BEFORE THE SELWYN DISTRICT COUNCIL

IN THE MATTER a Proposed Variation to the Partially
Operative Selwyn District Plan
(Variation 2) 157 Levi Road Rolleston
Foodstuffs (South Island) Properties
Limited.

STATEMENT OF EVIDENCE OF Gabriel Ross

- 1.5 In this matter, I was engaged by Selwyn District Council (SDC) to provide a peer review of the applicants LEA, supporting graphic attachments, and submissions on the notified proposed Private Plan Change Request (**PPCR**) described as Variation 2, Large Formal Retail Zone (**LFRZ**) 157 Levi Road.

Figure 1: Proposed ODP overlay on Concept Plan

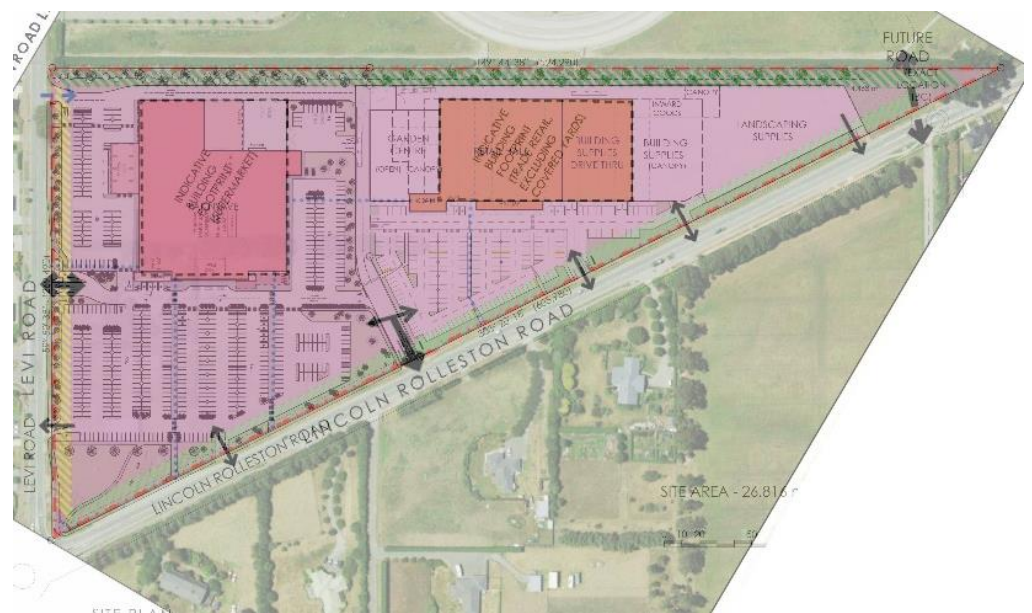
7.2 The application illustrates a conceptual LFRZ development⁴ in the form of a Mitre10 Retail Centre comprised of a 6,576 sqm primary building connecting to a 2,295 sqm building supplies canopy and 2,010sqm garden centre. This is set back off the eastern boundary by 18m. At the northern end of the conceptual Mitre10 building there is an approximately 77m separation from the western Lincoln Rolleston Road boundary. Due to the triangular shape of the Site, the southern end of the conceptual building footprint is unavoidably closer to the western boundary. The Concept Plan illustrates an offset of approximately 25m from the closest corner of the proposed building and approximately 12.5m to the Building Supplies Canopy.

- 10.8 My only concern with regards to boundary treatment is around the south-western interface with Lincoln Rolleston Road where the Conceptual site plan shows a canopy corner relatively close to the road. I have estimated this to be approximately 12.5m from the boundary of the site with Lincoln-Rolleston Road. Due to this proximity and the proposed vehicle access point at this area requiring a gap in the boundary planting, the built form, subject to detailed design could be significantly more visually dominant in this area. As noted in the following sections I proposed some further requirements to help provide greater certainty at the ODP level. This includes assessment criteria such as façade modulation, canopy height on the southwestern corner, and increasing building setbacks including the Canopy structure to accommodate additional mitigation planting to provide adequate screening and filtering of views.

- c) Include a 20-meter building setback requirement to the Lincoln Rolleston Road boundary including any proposed covered outdoor areas or canopy structures to maintain sufficient setback for mitigation planting to filter views of the building.
